November 10, 2026
7:00 PM
Planning Board Agenda

Continue public hearing and continue review of application for Amended Site Plan Approval, 364 Main Street, Mixed-Use Commercial and Residential, submitted by 364 Main BCN LLC.

Re: 364 Main BCN LLC – Supplemental Submission
Application for Site Plan Amendments Involving Field Changes
Property: 364 Main Street, Beacon, New York 12508 (ID: 6054-29-006819)

RESPONSE LETTER

Drawing Number: A-006

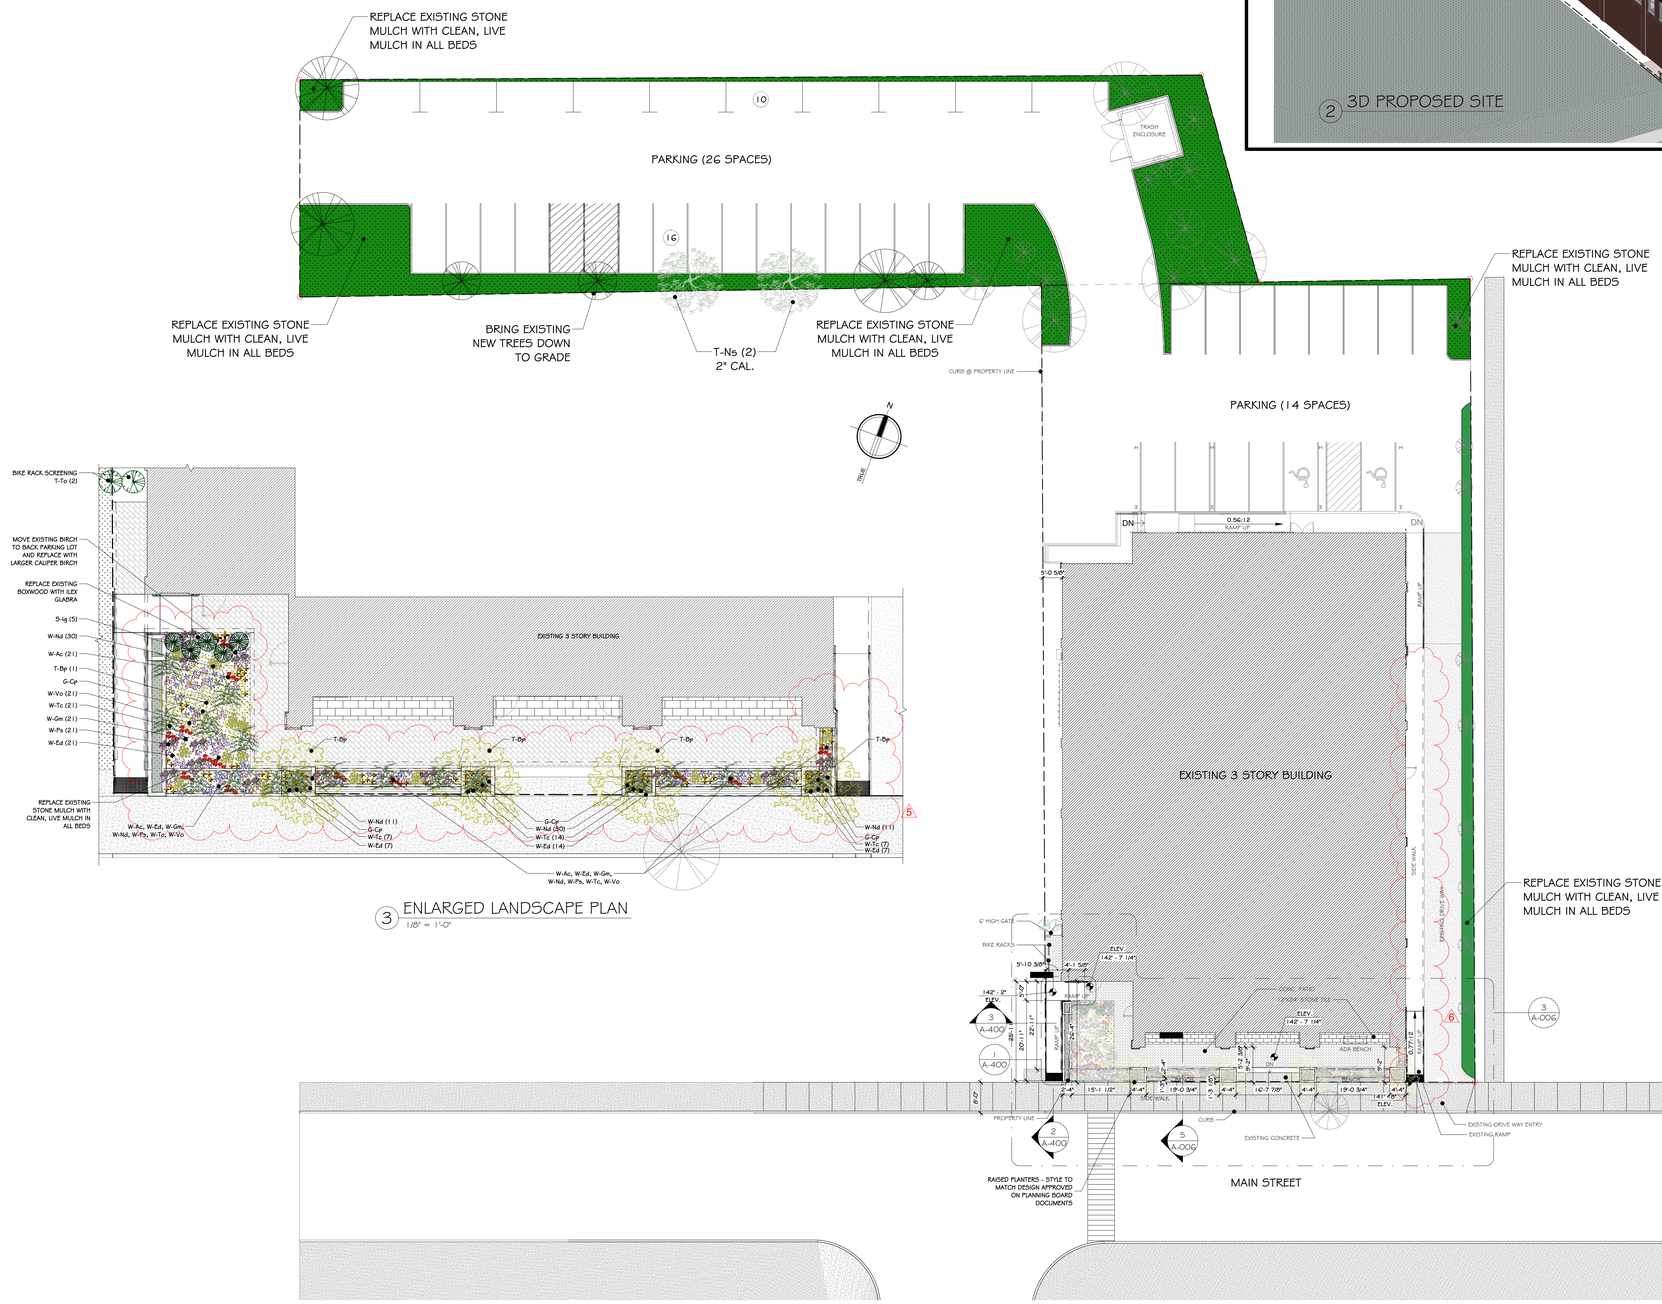
Comment No.	Topic	Page No. / Section No.	Reviewer Comment	Respondent	Response
2	Landscape	Landscape Plan	The submitted landscape plan shall be updated to reflect who prepared the plan.	Landscape Restorations / ADG	This has been addressed. The review letter addressed the Landscape Plan Revision dated August 21, 2026. The revised Landscape Plan dated September 8, 2026, submitted with the applicant's letter of September 30, 2026, identifies the preparer, Landscape Restorations of Beacon, New York, in its title block.
3	Landscape	Landscape Plan; A-006	The landscape plan shall include an enlarged view for the landscaping proposed along the front of the building, so that it is clearly detailed and legible.	Landscape Restorations / ADG	This has been addressed. The September 8, 2026 Landscape Plan includes an Enlarged Landscape Plan (Detail 2) of the planting along the Main Street frontage, with each species and quantity labeled. The same enlarged plan and plant list are shown on Sheet A-006 (Detail 3).

4	Landscape	Landscape Plan; A-006	The landscape plan reflect three (3) trees (Thuja) to be planted to the west side of the building to screen the bike racks. It appears that 1 of the proposed trees is being planted on the neighbors parcel. Has the owner of the neighboring parcel agreed to the planting of a tree on their parcel? If so, a copy of the written agreement shall be provided to the Planning Board. If not, then the tree should be relocated so that all plantings occur on the subject parcel.	Landscape Restorations / ADG	This has been addressed. The September 8, 2026 Landscape Plan reduces the bike rack screening to two (2) Thuja occidentalis 'Emerald Green' (T-To), both located on the subject parcel beside the building at the bike racks. No planting is proposed on the neighboring parcel, and no agreement with the adjoining owner is required. See also Sheet A-006.
5	Architectural	A-006	The trees and callout for "plants in stone" on Sheet A-006 shall be revised to reflect the landscape plan submitted. The landscape plan reflects that the stone is being removed, and that there is a singular tree in the landscaped area in the front left	ADG	This has been addressed. Sheet A-006 has been revised to agree with the September 8, 2026 Landscape Plan. The "plants in stone" callout has been removed, the beds are noted to have the existing stone mulch replaced with clean, live mulch, and the front

Comment No.	Topic	Page No. / Section No.	Reviewer Comment	Respondent	Response
			corner.		left landscaped area shows the single white birch (T-Bp) shown on the landscape plan. The landscape plan's plant list and enlarged plan have also been added to the sheet.

Drawing Number: **A-007**

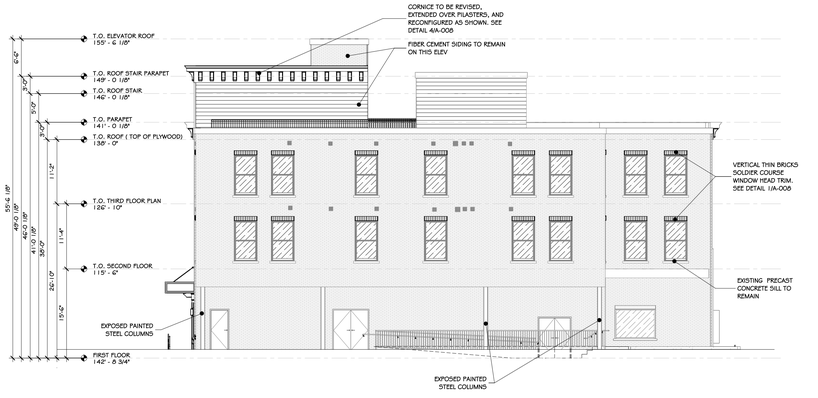
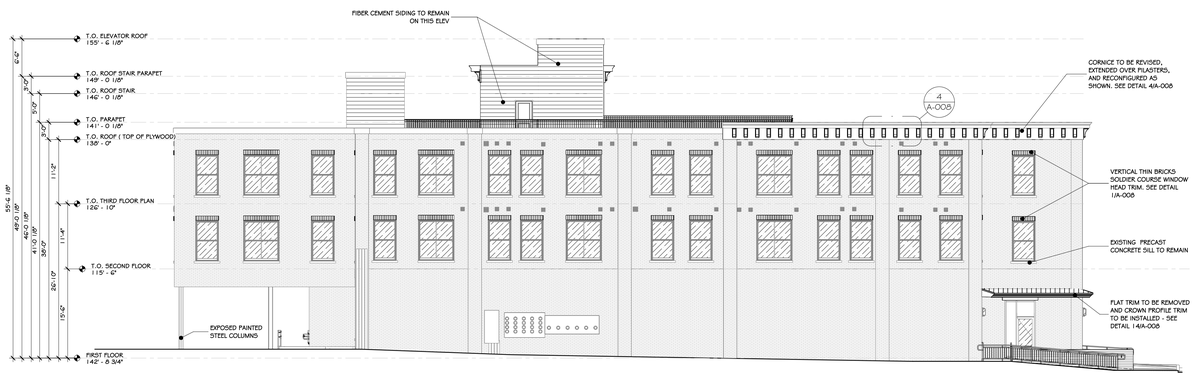
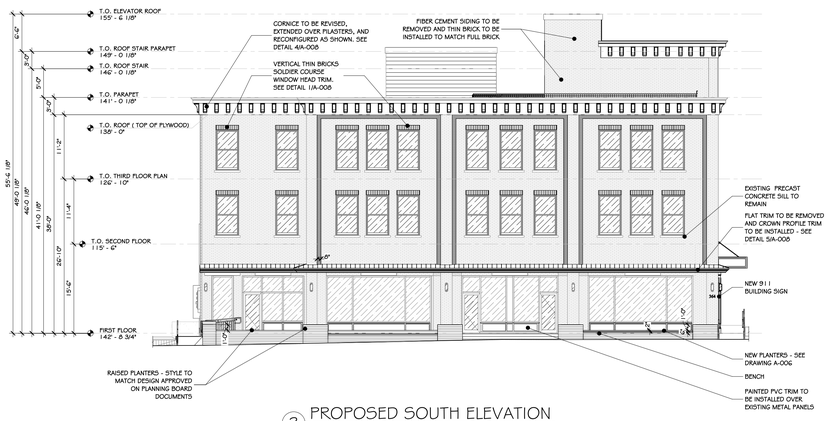
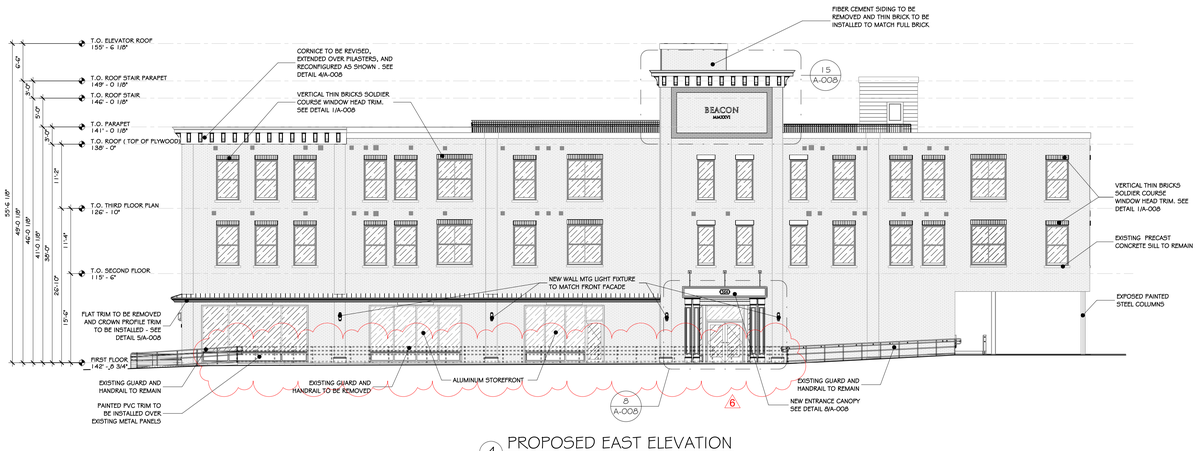
6	Juliet Balconies & Associated Doors	Juliet balconies with double doors on East and West elevations.	Balconies removed; replaced with standard operable double windows.	Balconies provided no usable outdoor space and introduced long-term safety and maintenance concerns (door leaks/drafts) without resident benefit. Contractor/developer noted that these create continued maintenace issues on other building that they own.	Maintain field change as constructed. Operable windows were installed at the same width and head height as the double doors, ensuring the building's scale and fenestration rhythm remained consistent. Additionally, we propose to add juliet balony railings at the four windows along the east side of the building, which are the most visible to Main Street. (Post ARB) All ARB members agreed that juliet balconies were not ideal and suggested window planter boxes as a more appropriate decorative element. (Post ARB 2) With the overall improvements to the stair tower proportions and east façade articulation, the consensus was that additional decorative elements at these windows were no longer necessary.

7	Stair & Elevator Bulkhead Cladding	Thin brick cladding.	Fiber cement board siding (Hardie Plank) was installed.	Substituted as a material adjustment and coordinated directly with the building department during the construction phase.	Despite field approval, with the exception of the rear stair tower, we propose removing the fiber cement siding and installing thin brick cladding to restore material continuity with the primary façade. (10-27-26) The drawings have been updated to reflect the extent of work as noted above.

Drawing Number: A-008

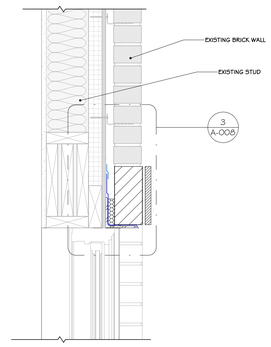
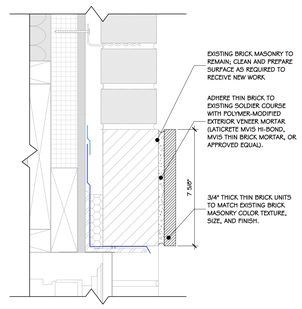
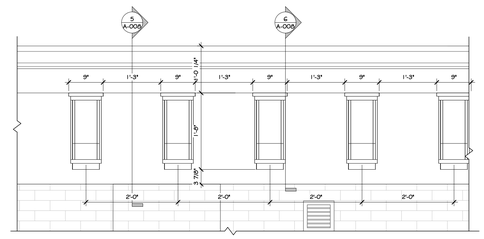
18	Window Head Detailing	PB renderings showed straight brick head; PB elevations showed arched heads. City-approved CDs called out an arched Azek profile.	A straight full-brick soldier course window head detail was installed.	The contractor opted for a straight soldier course brick head, feeling that it was compatible with the building's overall character and the full-brick masonry upgrade.	We propose to install painted PVC Fypon window headers toto align with the approved drawings. (Post ARB) The arched window head from the original design was determined to be working against the overall aesthetics of the façade. A straight thin brick soldier course header is proposed to add shadow and depth.
	19	Residential Entrance (Main Street)	A projected entrance canopy was specified.	The canopy was removed, and a recessed entryway was provided.	It was felt that the projected canopy was going to be a maintenance issue, and the recessed entryway would achieve the same technical solution, creating a permanent, integrated arrival point that protects residents from the weather	To address architectural detailing associated with a primary entrance point, we are now proposing to add the canopy and construct flanking pilasters to more closely align with the design and proportions of the original design. (Post ARB) Proportions and detailing of the canopy were revised per ARB comments. (Post ARB 2) Proportions and detailing were further revised to lighten and simplify the pilasters and canopy.

The same cannot be said for fixing the facing on the building around all of the windows. The depth of the reveal is a major feature affecting the flatness and architectural interest of the building. The proposed half-brick fix is completely insufficient. Accepting that, essentially saves the develioper money and would further provide this develoiper and others to folllow the wriong lessson that the can wait out the City and get away with bad behavior: We can get away with asking and getting permissiion after the fact
and get forgiveness.
